V2500-A1/A5/D5 SERIES PROPULSION SYSTEM SERVICE BULLETIN

This document transmits Revision 1 to Service Bulletin V2500-ENG-70-0926

INFORMATION – ENGINE – PROVIDE A NEW NO. 3 BEARING**1. Planning Information****A. Effectivity**

Engine - No. 3 Bearing
Figure 1

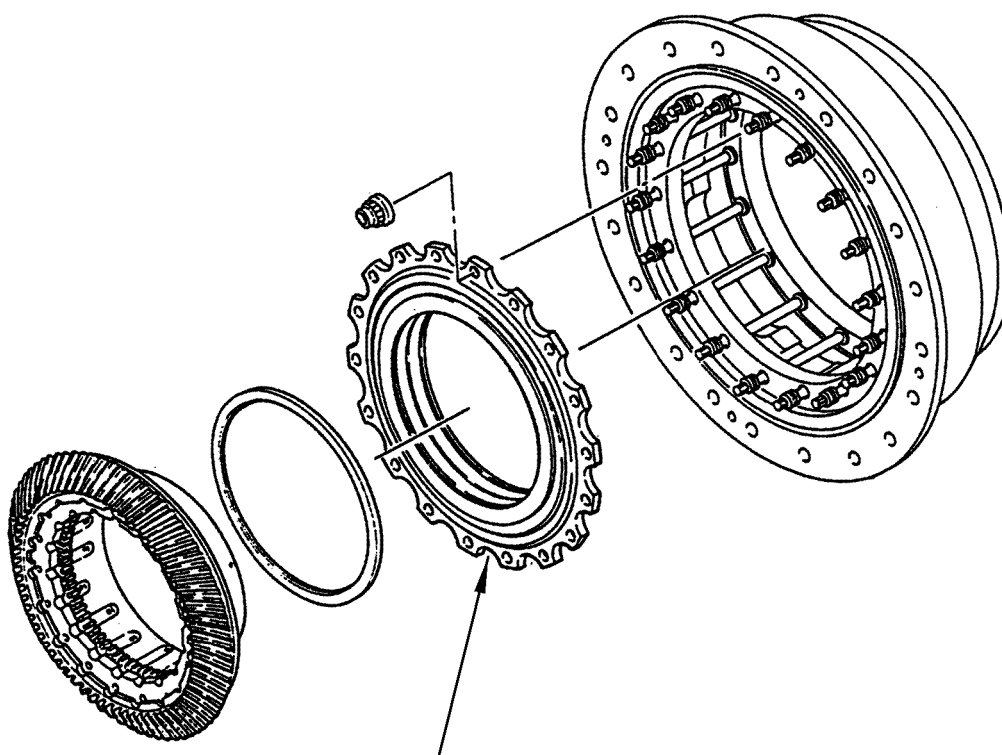
Introduce a second source for the No. 3 Bearing on V2500-A5/D5 engines to support spares demand.

New parts are directly interchangeable with PN 2A1170.

R	01-100	2A4022	1	No. 3 Bearing	-	(2)(B)(I)
---	--------	--------	---	---------------	---	-----------

REF BEARING PN 2A4022
